Metro Outer Joint Development Assessment Panel Agenda

Meeting Date and Time: Monday, 4 September 2023; 10:00am
Meeting Number: MOJDAP/270
Meeting Venue: Electronic Means

Subject: Response to application seeking Development Approval for a childcare premises at Lot 194 and 193 (No.4 and 6) Malibu Road, Safety Bay.

That the Metro Outer Joint Development Assessment Panel resolve to **REFUSE** Development Application reference DAP/23/02487 and the amended plans and supporting information received on 10 July 2023:

1 LANDSCAPING PLAN
SCALE 1 : 200

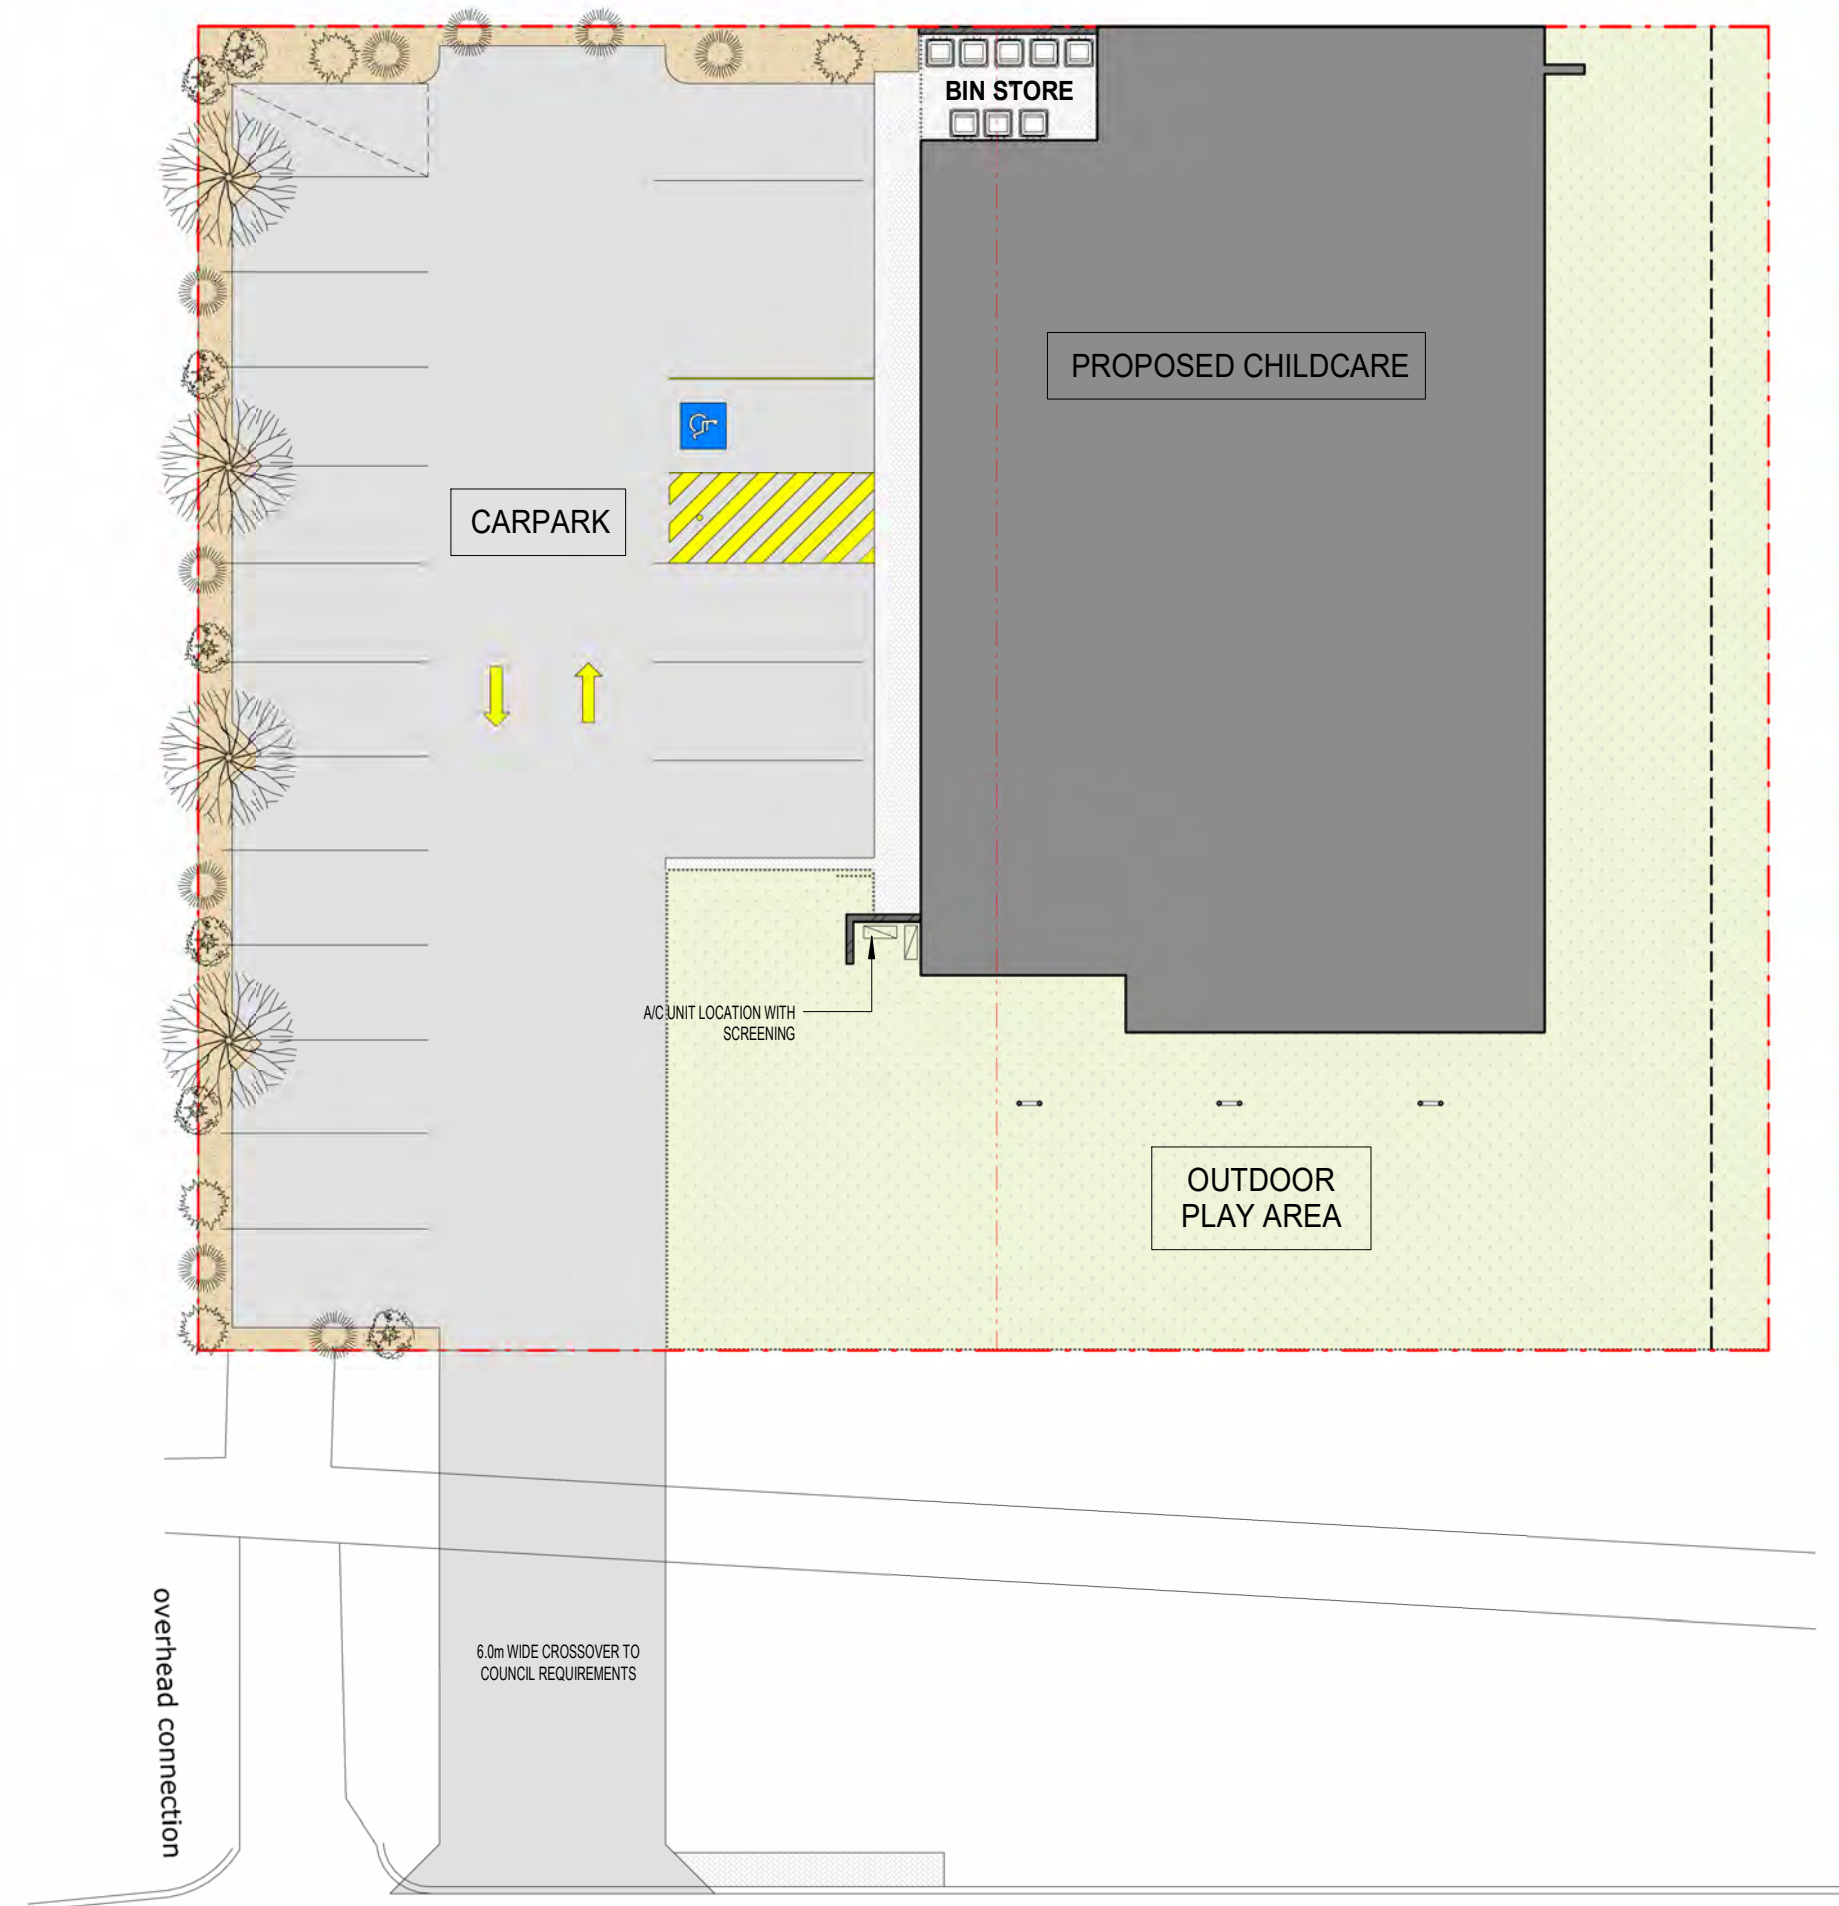
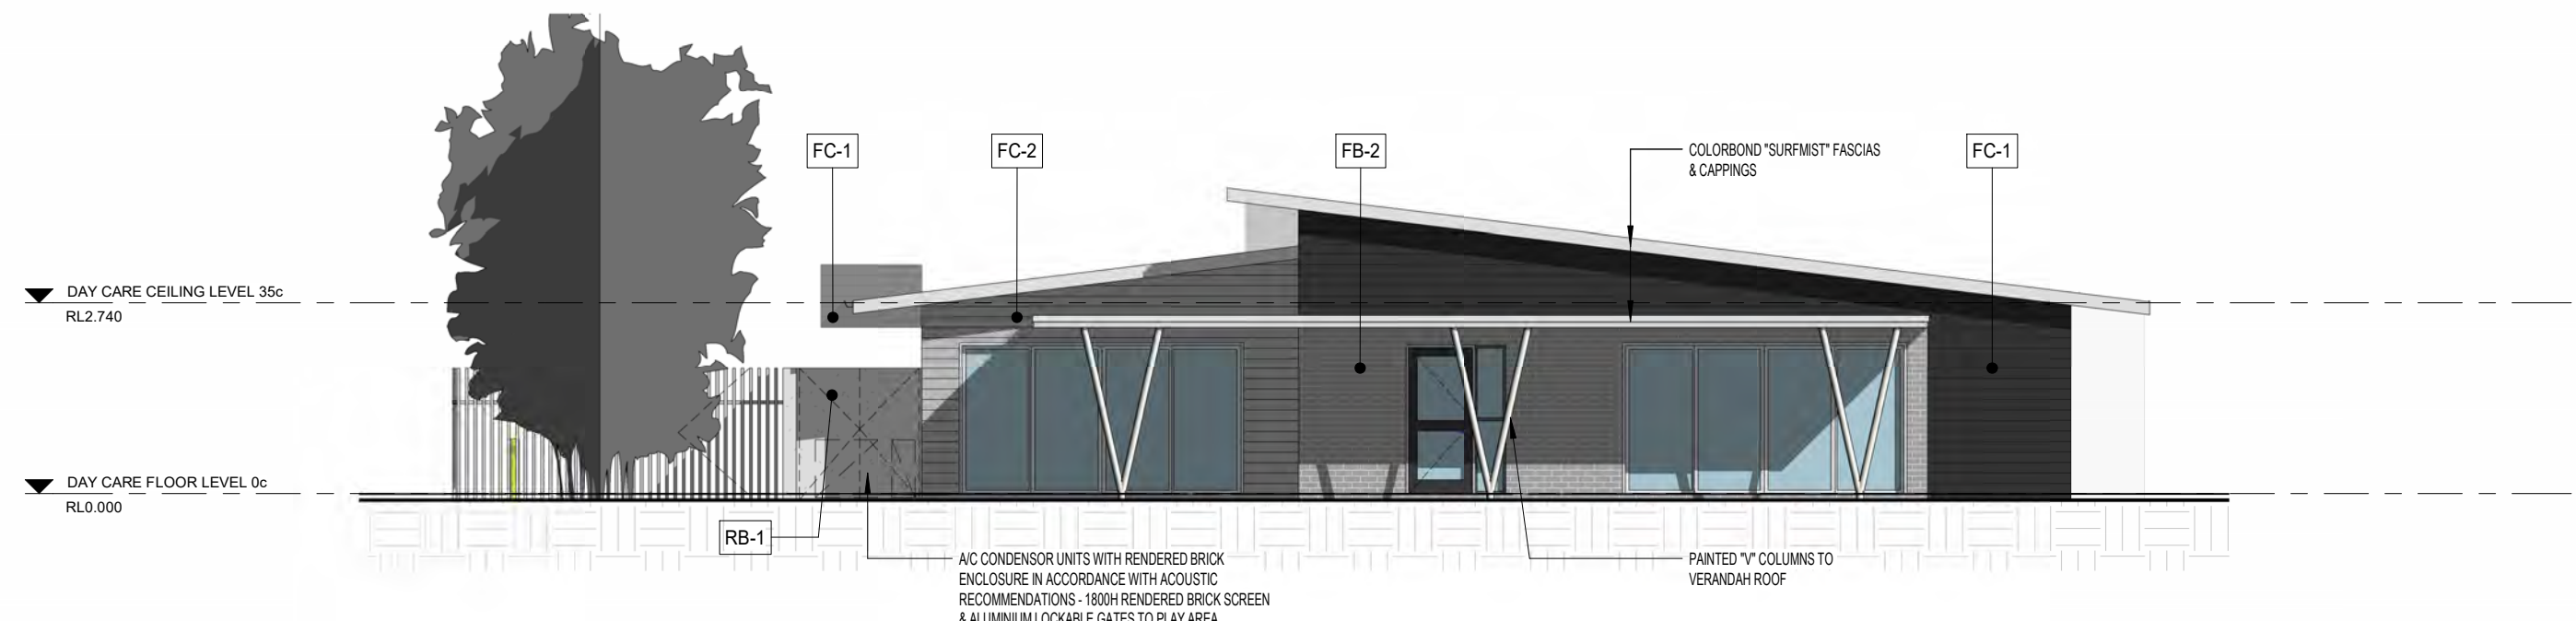
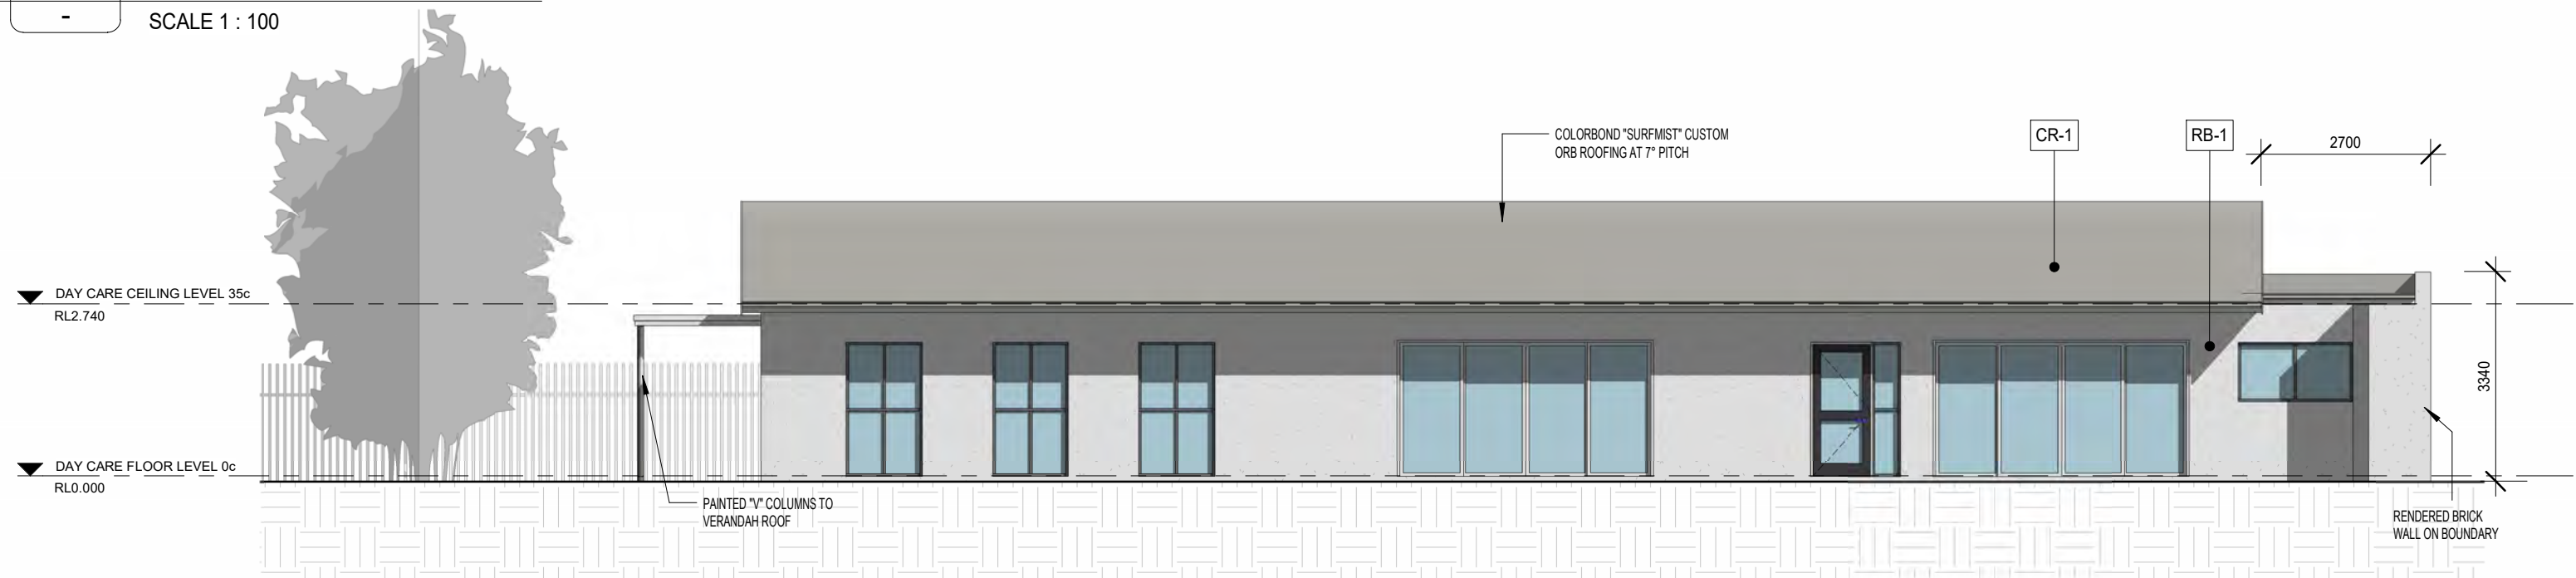
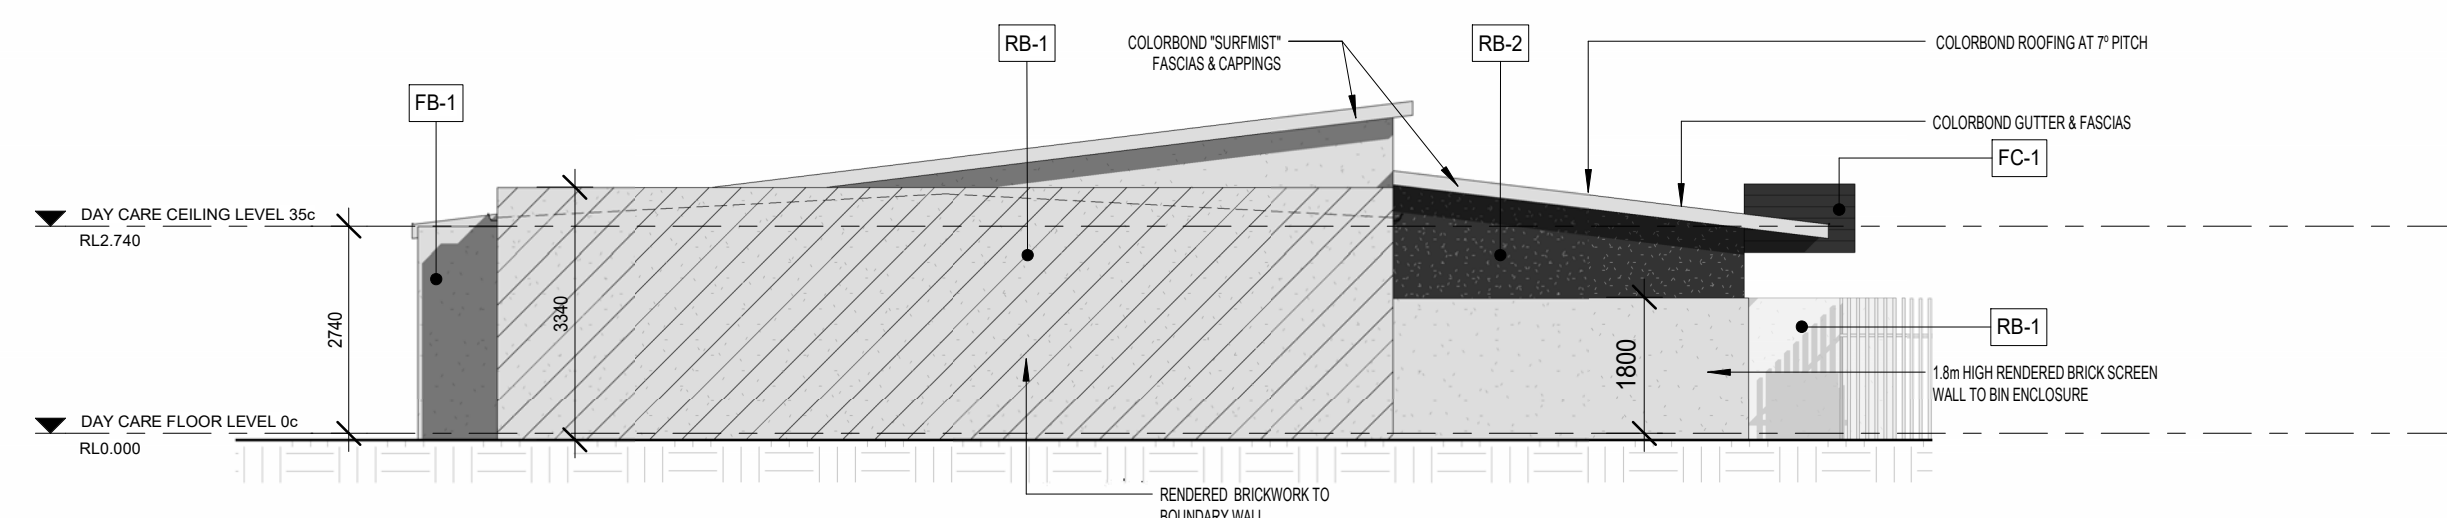
By “flipping” the design, the particulars of the proposed development, such as noise generation, traffic generation, parking requirements, operating hours, number of children and staff, etc. will not change. As a result, the findings of the traffic report are unchanged. In relation to the access location, we acknowledge that the crossover will move closer to the Safety Bay Road and Malibu Road intersection. However, the preliminary advice from the traffic engineer is that this an acceptable outcome. The findings of the EIA will improve.

To address the City's third reason for recommending refusal and to meet the relevant deemed-to-comply requirements outlined in State Planning Policy 7.3 – Residential Design Codes (**the R-Codes**), the following amendments to the Development Plans have been made:

As a result of these amendments to the Development Plans, the proposed development now satisfies the 'Lot boundary setback' deemed-to-comply requirements outlined in SPP 7.3. Therefore, the proposed development now presents an acceptable level of impact to the adjoining residential property situated to the west of the subject site, with respect to the height of the rear boundary wall.
